2025-CRW-1019

Re: Addendum No. Two (2)

Snow Removal Equipment (SRE) Building
3-54-0003-087-2025 (Design)
3-54-0003-XXX-2026 (Construction)
West Virginia International Yeager Airport (CRW)

AMERICAN ELECTRIC POWER COMPANY
DISTRIBUTION STANDARDS

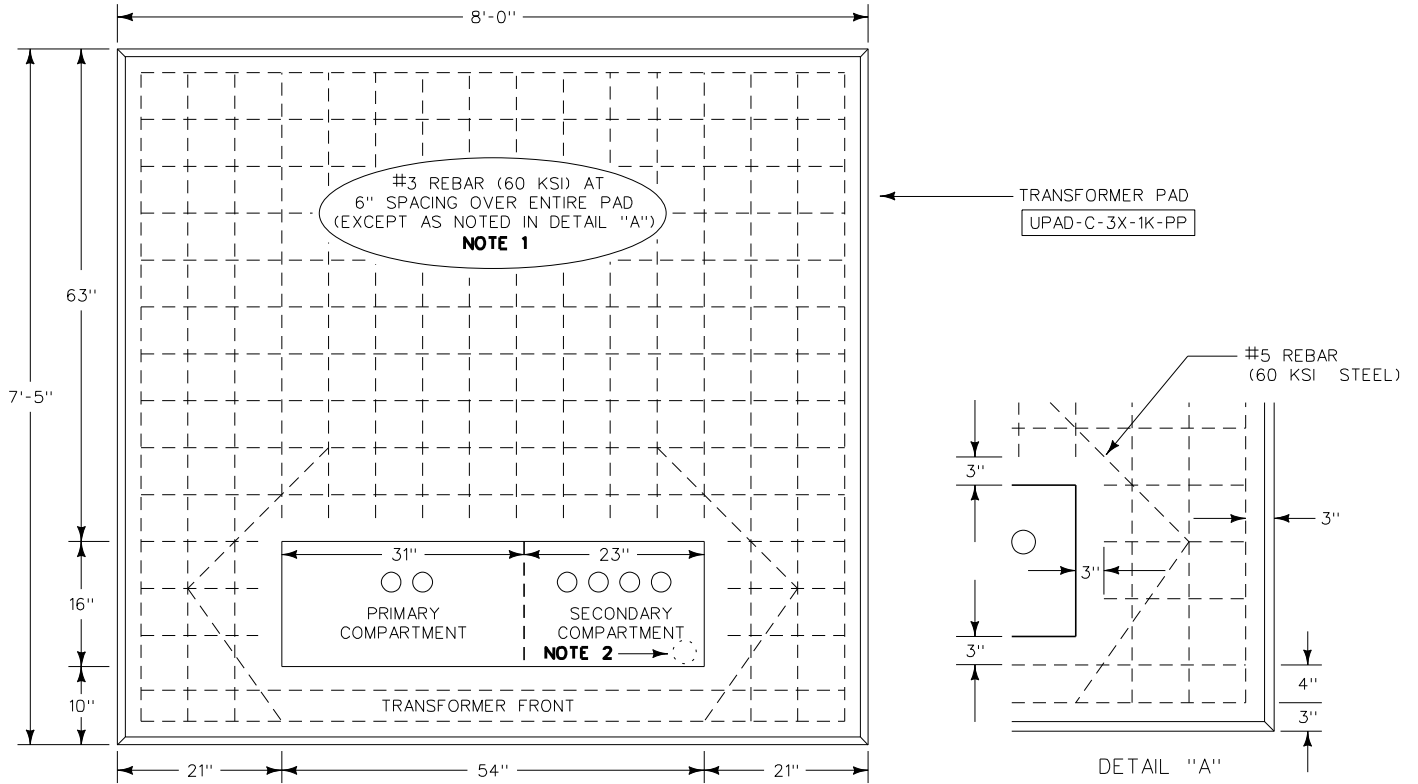
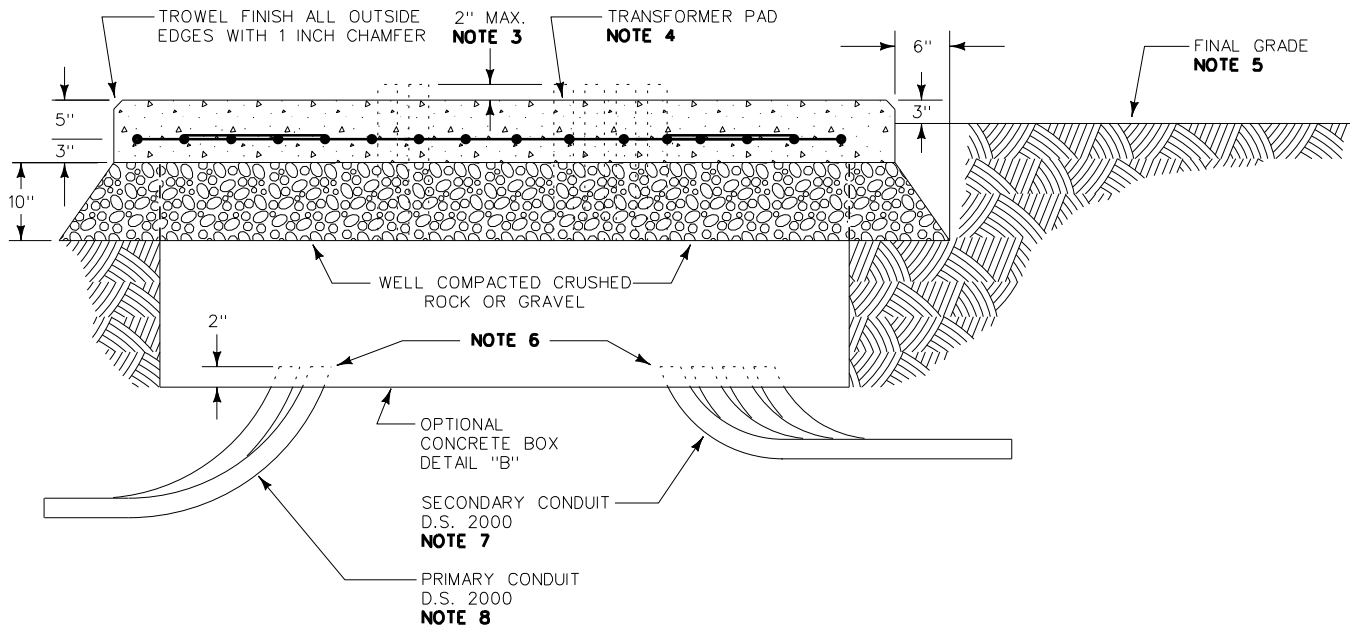
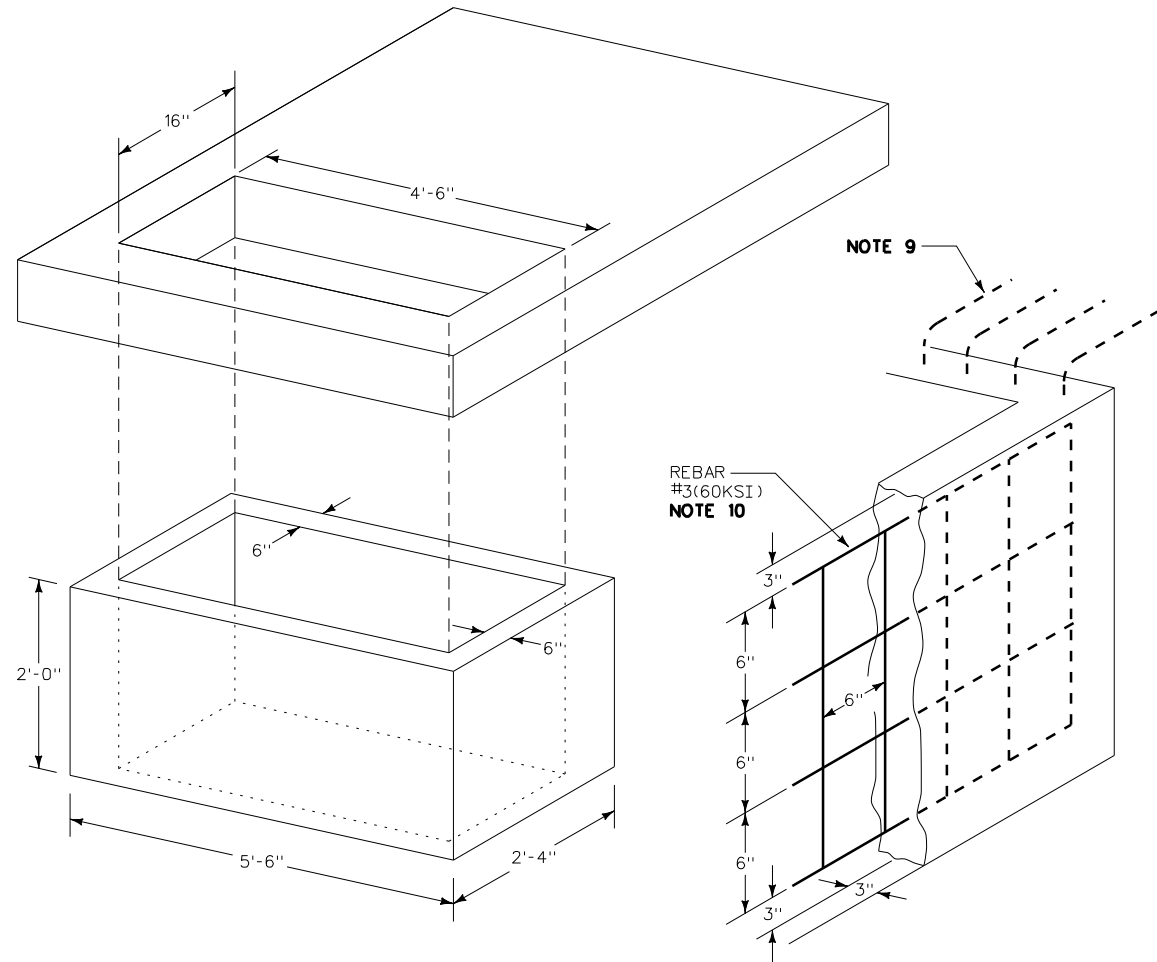
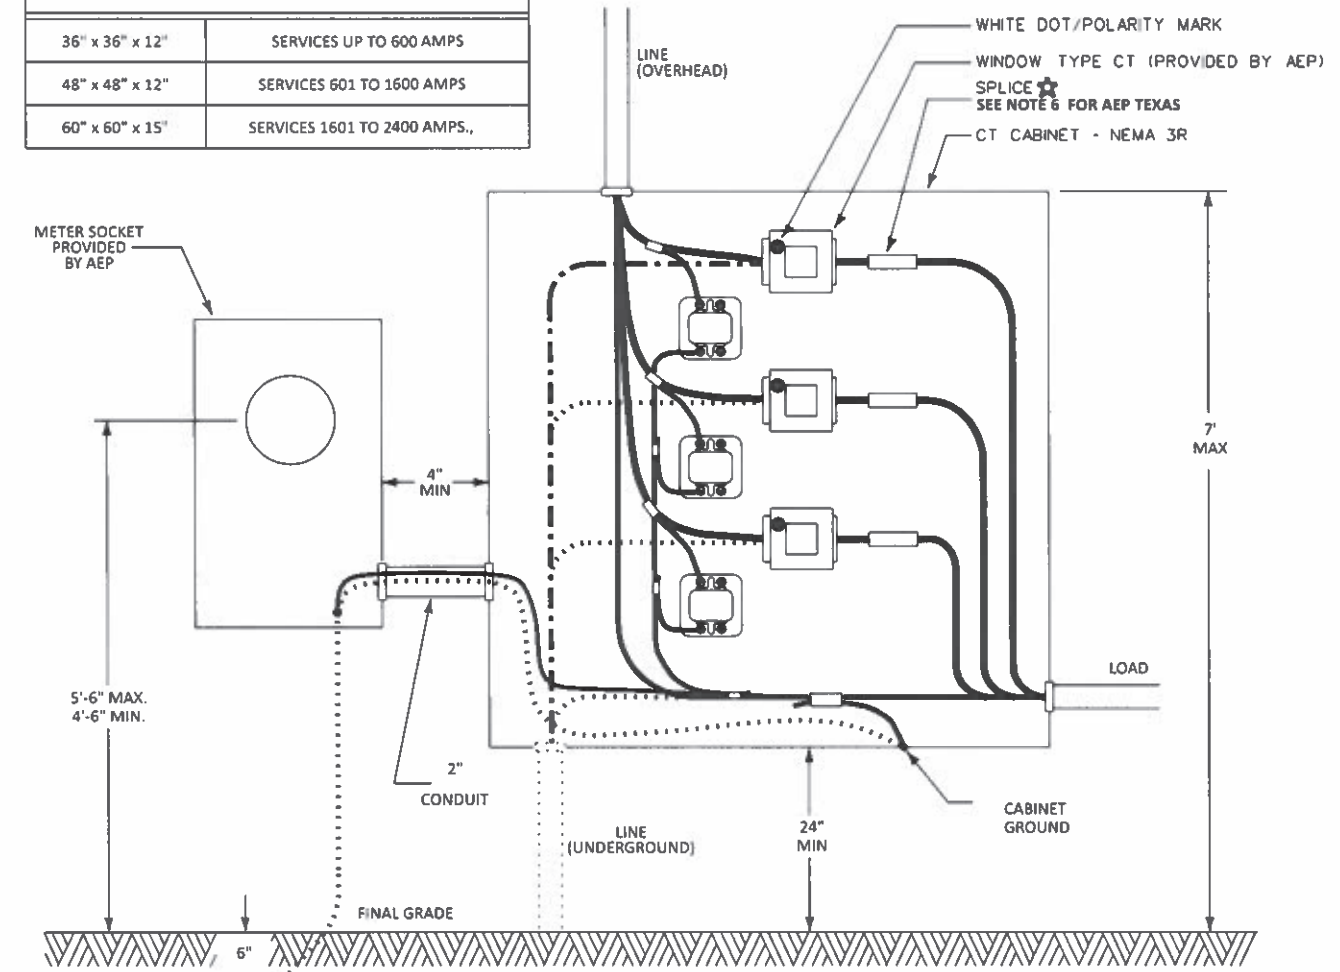
AEP Requirements – Attachment No.2 contains the AEP standard details for the transformer pad and the CT Cabinet.
